Final Environmental Assessment
Utah Coal and Biomass Fueled Pilot Plant
Kanab, Utah

DOE/EA-1870

December 2011

Title: Final Environmental Assessment for the Utah Coal and Biomass Fueled Pilot Plant (DOE/EA-1870)

Figure 2-3. Conceptual Drawing of Pilot Plant

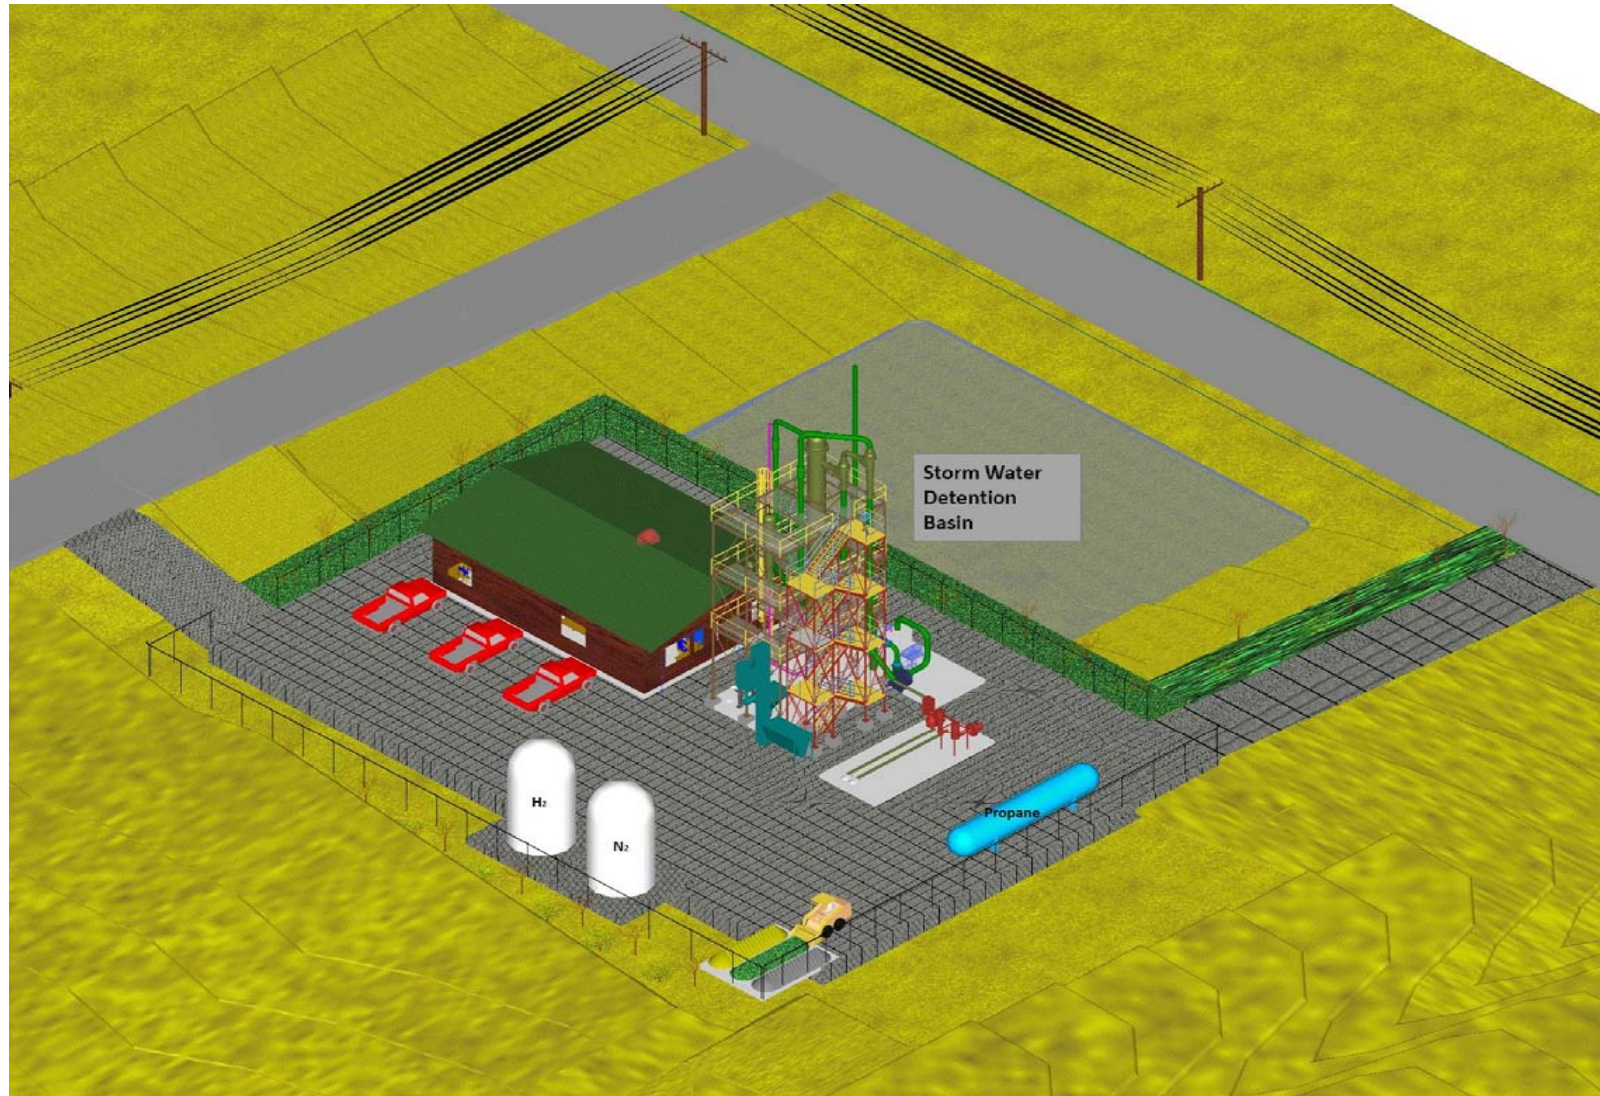
pond; no evaporation pond is discernable in Figure 2-3. Please explain what is meant by "returned to the environment". Would this effluent truly be left to evaporate in a pond?

Facility Processes and Equipment (Section 2.7.2.) makes no mention of an evaporation pond; no evaporation pond is discernable in Figure 2-3. Please explain what is meant by "returned to the environment". Would this effluent truly be left to evaporate in a pond?

Facility Processes and Equipment (Section 2.7.2.) makes no mention of an evaporation pond; no evaporation pond is discernable in Figure 2-3. Please explain what is meant by returned to the environment. Would this effluent truly be left to evaporate in a pond?

Facility Processes and Equipment (Section 2.7.2.) makes no mention of an evaporation pond; no evaporation pond is discernable in Figure 2-3. Please explain what is meant by "returned to the environment". Would this effluent truly be left to evaporate in a pond?

Section 2.7.2 and Figure 2-4 cover Viresco's operational plans as implemented under the proposed action (30-day); the evaporation pond discussed in Section 5.2 refers to one of Viresco's options in handling

Figure 2-4. Utah Coal and Biomass Fueled Pilot Plant Processes

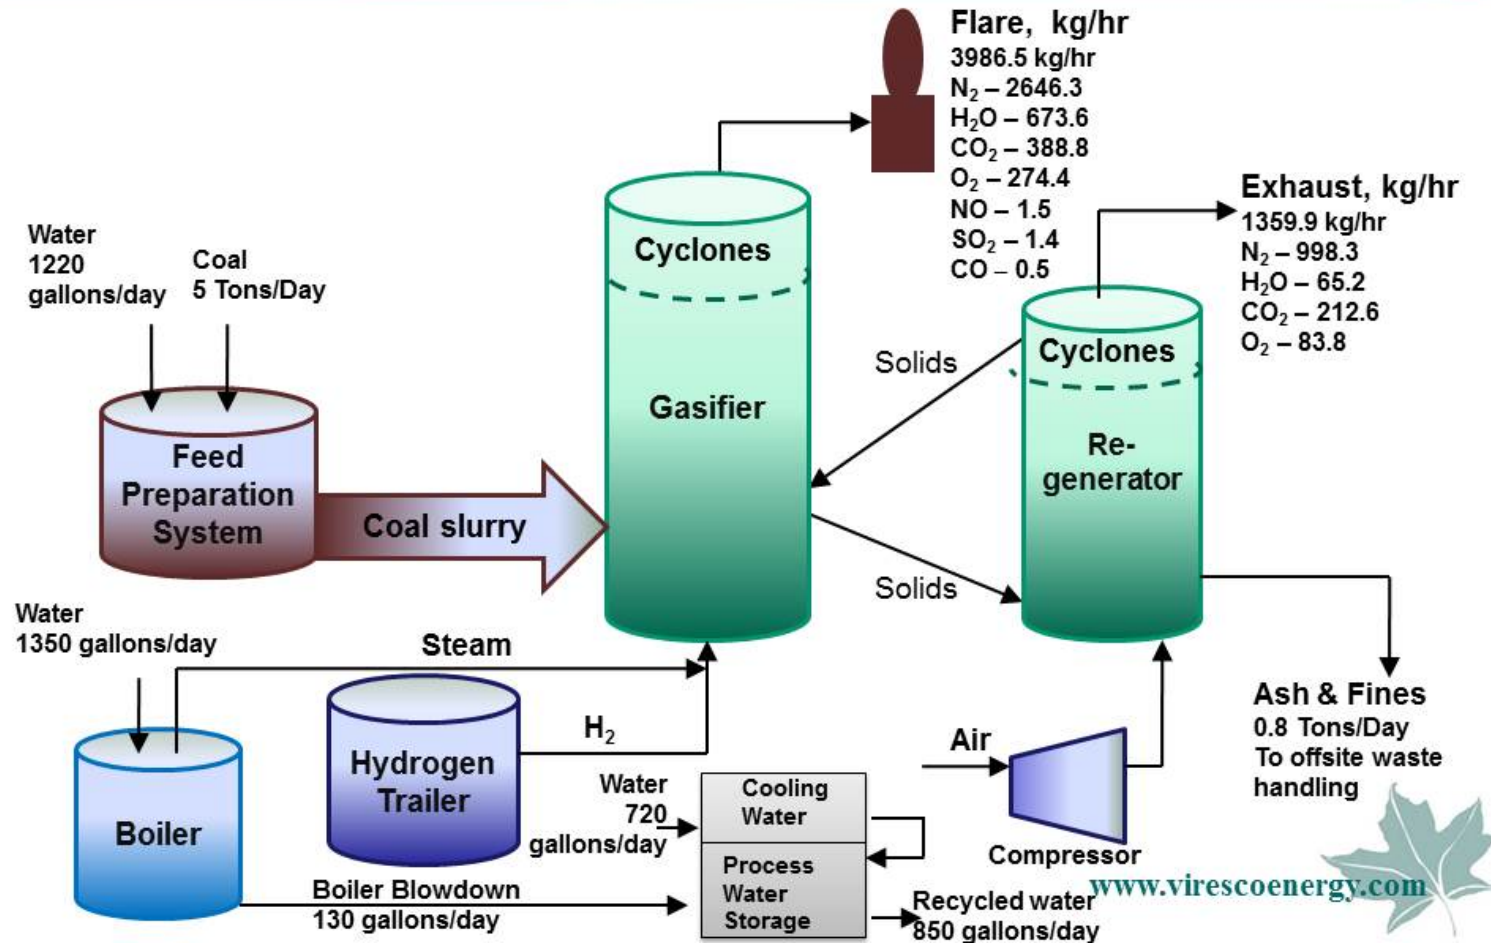
- 6-03** Figure 2-4 shows that 100% of the exhaust from the cyclone re-generator is nitrogen, water, carbon dioxide and oxygen. Do you really believe there won't be any toxic compounds, methane gas, or other substances released into the air?

- 15-11 P 15 par3:
Information about potable water use contradicts itself and seems intentionally misleading within the table and in the illustration (Figure 2-4) and paragraphs on p 15. Separating potable vs. non-potable water makes no sense since the paragraph states that ALL water will be supplied by Kanab's potable water system:

- Process water ... 1,270 gpd for a total of 38,100 gallons for 30 days of operation.
 (Figure 2-4 shows 1320 gpd.)The daily potable water demand by the Pilot Plant when it is operational would be limited to the needs of a workforce of 9 employees at 250 gpd for a total of 7,500 gallons for 30 days of operation. Both the process water and the potable water would be supplied by the City of Kanab's potable water system. The total daily rate of potable water use (1,520 gpd) (according to the diagram this figure should be 1370) represents 0.03 percent of the existing wells and spring capacity that supply the City of Kanab's potable water system.

- 48-03** 1. On page 16, section 2.7.2 and page 17, Figure 2.4 include an air compressor for the regenerator. This compressor is not addressed in the emission calculations. Please verify that this compressor is electrically-powered and not run on hydrogen or propane.

"Most notable emission would be of carbon monoxide and is estimated to be less than 16 tons for 130 days of operation." Yet Per figure 2-4, Flare emits 9183 lbs/hr= 5 tons/hr!

Total process water demand (non-potable use) for the Pilot Plant under the proposed action would be approximately 3,290 gpd, potentially all of it supplied from the City of Kanab. It is anticipated that up to 850 gpd would come from recycled water from other plant processes, which could reduce the process water demand to 2,440 gpd. Additionally, it is estimated that employees of the facility would use 250 gpd of the City's water (potable water use). Section 2.7, including Table 2.7-1 and Figure 2-4, has been revised to clarify water demand and source of the water supply.

Section 2.7.2 and Figure 2-4 cover Viresco's operational plans as implemented under the proposed action (30-day); Section 2.8 discusses operational plans considered under the connected action (130-day maximum). See response to comment number 39-04 regarding the statement "returned to the environment."
